EA802 Whitewater Hall

Replace Operable Windows and Interior Renovation
IU#20240646

ADDENDUM NO. 2

24 October 2025

THIRD FLOOR
PLAN -
SOUTHWEST
A231

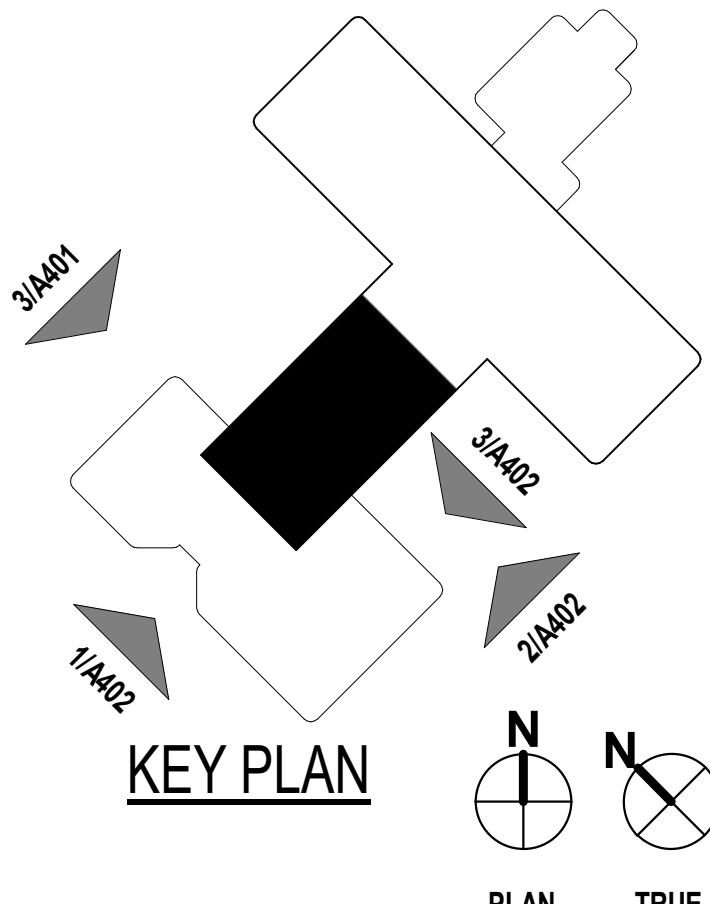
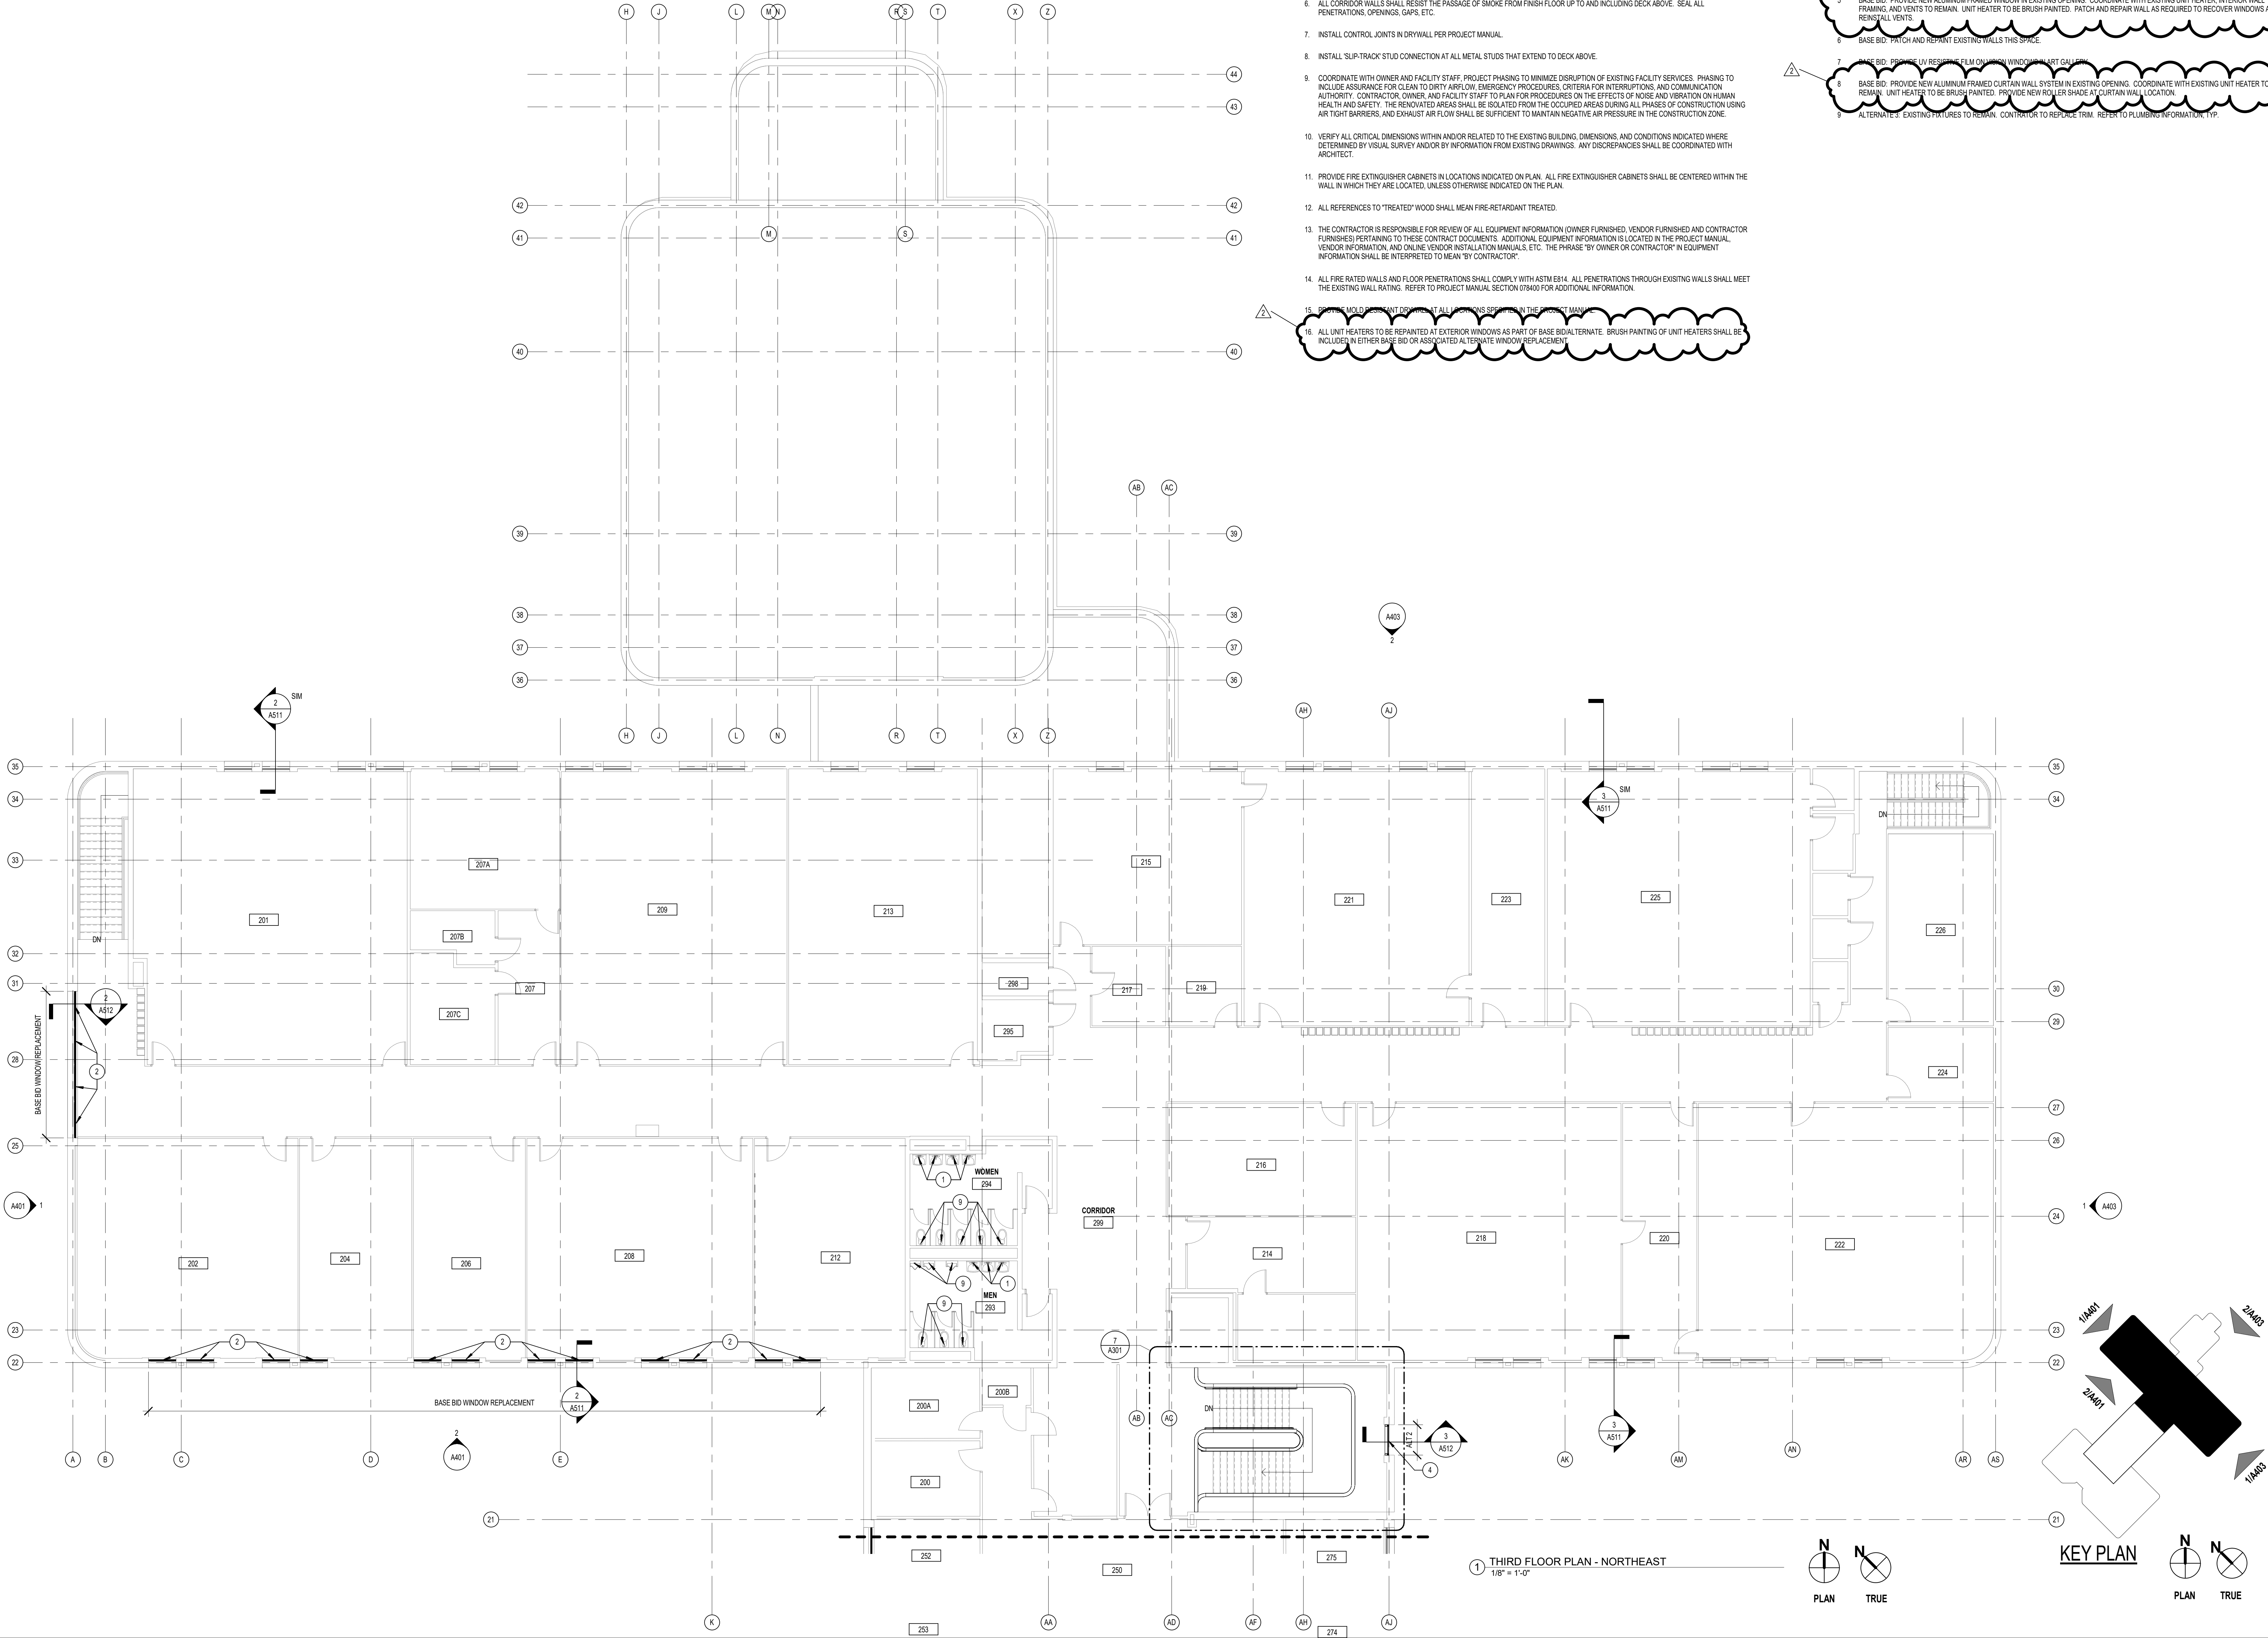
-
- b. Revise Specific Floor Plan Notes 2, 3, 4, 5, and 8 as shown on attached revised sheet.
 - 3. Sheet A231 – Third Floor Plan – Southwest
 - a. Revise General Plan Note 16 as shown on attached revised sheet.
 - b. Revise Specific Floor Plan Notes 2, 3, 4, 5, and 8 as shown on attached revised sheet.
 - 4. Sheet A232 – Third Floor Plan – Northeast
 - a. Revise General Plan Note 16 as shown on attached revised sheet.
 - b. Revise Specific Floor Plan Notes 2, 3, 4, 5, and 8 as shown on attached revised sheet.

- EXISTING MOLD PRESENT DRYWALL AT ALL LOCATIONS SPECIFIED IN THE PROJECT MANUAL.
- ALL UNIT HEATERS TO BE REPAINTED AT EXTERIOR WINDOWS AS PART OF BASE BID/ALTERNATE. BRUSH PAINTING OF UNIT HEATERS SHALL BE INCLUDED IN EITHER BASE BID OR ASSOCIATE ALTERNATE WINDOW REPLACEMENT.

- BASE BID: EXISTING PORCELAIN FIXTURES TO REMAIN. CONTRACTOR TO REPLACE TRIM. REFER TO PLUMBING INFORMATION, TYP.
- BASE BID: PROVIDE NEW ALUMINUM FRAMED WINDOW IN EXISTING OPENING. COORDINATE WITH EXISTING UNIT HEATER TO REMAIN. UNIT HEATER TO BE BRUSH PAINTED. PROVIDE NEW ROLLER SHADE AT WINDOW.

- ALTERNATE 1: PROVIDE NEW ALUMINUM FRAMED CURTAIN WALL SYSTEM IN EXISTING OPENING. COORDINATE WITH EXISTING UNIT HEATER TO REMAIN. UNIT HEATER TO BE BRUSH PAINTED. PROVIDE NEW ROLLER SHADE AT CURTAIN WALL LOCATION.

- ALTERNATE 2: PROVIDE NEW ALUMINUM FRAMED CURTAIN WALL SYSTEM IN EXISTING OPENING. COORDINATE WITH EXISTING UNIT HEATER TO REMAIN. UNIT HEATER TO BE BRUSH PAINTED.

- BASE BID: PROVIDE NEW ALUMINUM FRAMED WINDOW IN EXISTING OPENING. COORDINATE WITH EXISTING UNIT HEATER, INTERIOR WALL FRAMING AND VENTS TO REMAIN. UNIT HEATER TO BE BRUSH PAINTED. PATCH AND REPAIR WALL AS REQUIRED TO RECOVER WINDOWS AND REINSTALL VENTS.

- BASE BID: PATCH AND REPAINT EXISTING WALLS THIS SPACE.
- BASE BID: PROVIDE UV RESISTANT FILM ON WINDOW WINDOW PART GALLERY.
- BASE BID: PROVIDE NEW ALUMINUM FRAMED CURTAIN WALL SYSTEM IN EXISTING OPENING. COORDINATE WITH EXISTING UNIT HEATER TO REMAIN. UNIT HEATER TO BE BRUSH PAINTED. PROVIDE NEW ROLLER SHADE AT CURTAIN WALL LOCATION.
